Report: ISSUE REPORT
Function: Test, Adjust, & Balance
Date: 02/08/2024

PROJECT
02-05-24 PERRY'S - VERNON HILLS, IL

Issue List

Issue Name : RTU-4: High on airflow

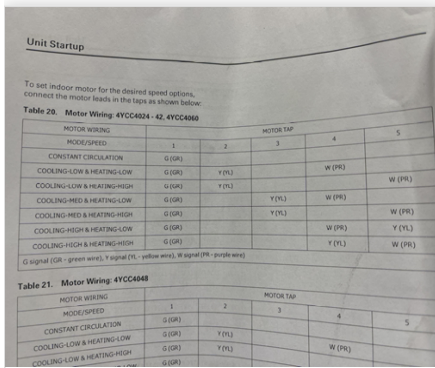
Description : RTU-4 is multispeed unit scheduled for 600cfm with speed taps. Plans call for constant volume. Unit is within design at Speed tap 1, where G is landed. Manual indicates placing W(heat) at 4 and Y (cool) at tap 2, puts heating and cooling to low speed, this is 940cfm. Not possible to wire all stages to same speed. No indication if jumpers are allowed.

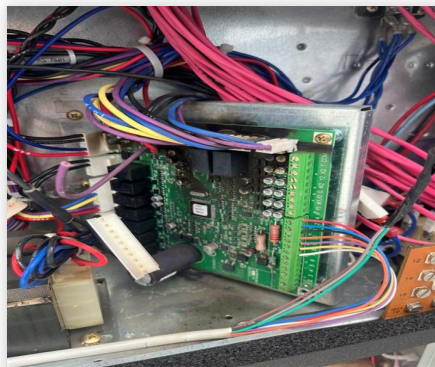
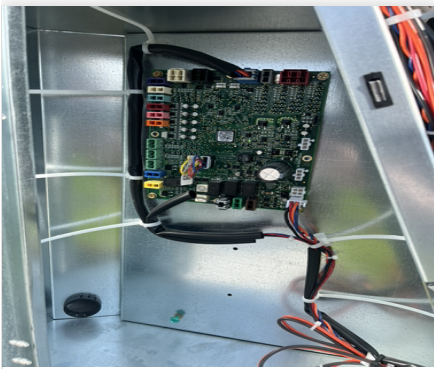
Issue Name : RTU-5: Not Operational
Description : RTU-5 is not operational as the control board is fried. Waiting on replacement board. Unit not yet balanced as result.
Created By : National TAB **Assigned To :** National TAB - Michael McDonnell
Status : Open
Priority : High **Asset Tag :**
Originated Date : 02/08/2024 - Michael McDonnell - National TAB
